PROJECT
VILLAGE GREEN AT
EAST COBB
E#7 2013

Z-59
(2013)

APPLICANT: Thomas Homes & Communities, LLC
678-898-3000

PROPOSED USE: Residential Senior Living

SITE PLAN
SCALE 1" = 50.0'

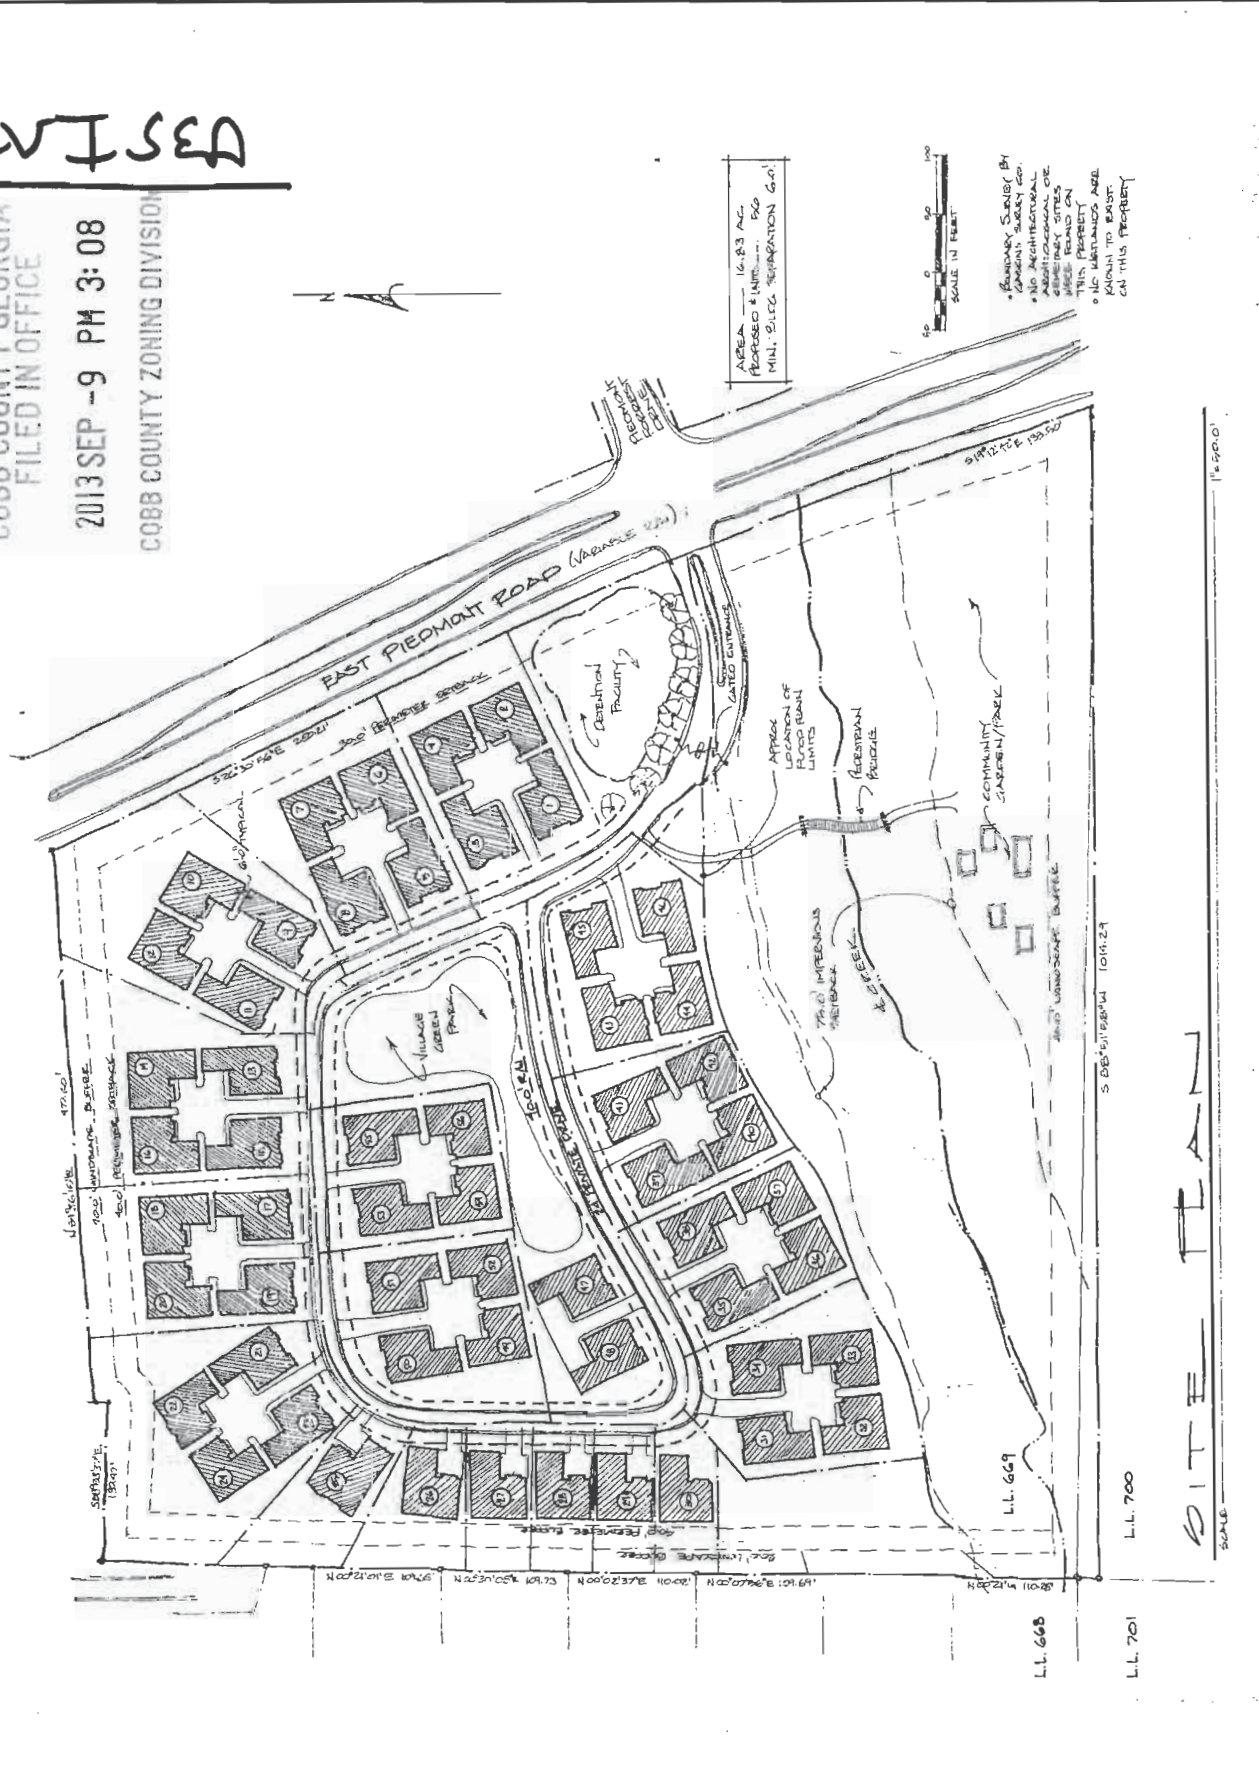
- Provide comprehensive hydrology/stormwater controls to include development of out parcels.
- Submit all proposed site improvements to Plan Review.
- Any **spring activity** uncovered must be addressed by a qualified geotechnical engineer (PE).
- Structural fill _____ must be placed under the direction of a qualified registered Georgia geotechnical engineer (PE).
- Existing facility.
- Project must comply with the Water Quality requirements of the CWA-NPDES-NPS Permit and County Water Quality Ordinance.
- Water Quality/Quantity contributions of the existing lake/pond on site must be continued as baseline conditions into proposed project.
- Calculate and provide % impervious of project site.
- Revisit design; reduce pavement area to reduce runoff and pollution.

- No Stormwater controls shown _____
- Copy of survey is not current – Additional comments may be forthcoming when current site conditions are exposed.
- No site improvements showing on exhibit.

- E. It is Staff's opinion that there are existing and changing conditions affecting the use and development of the property which give supporting grounds for approving the applicant's rezoning proposal, but limiting the density to a maximum of 2.5 units per acre. Applicant's proposal does not meet the density range of the *Cobb County Comprehensive Plan* for the LDR category (1-2.5 units per acre). The proposed development of 3.32 units per acre is at a higher density than other developments in the area. Staff is also concerned that the proposed plan does not meet the 15 feet between buildings requirement of the RSL (Non-Supportive) section on the ordinance.

- Maximum of 2.5 units per acre;
- Detached units;
- Final site plan to be approved by the Board of Commissioners;
- Fire Department comments and recommendations;
- Water and Sewer Division comments and recommendations;
- Stormwater Management Division comments and recommendations; and
- Department of Transportation comments and recommendations.
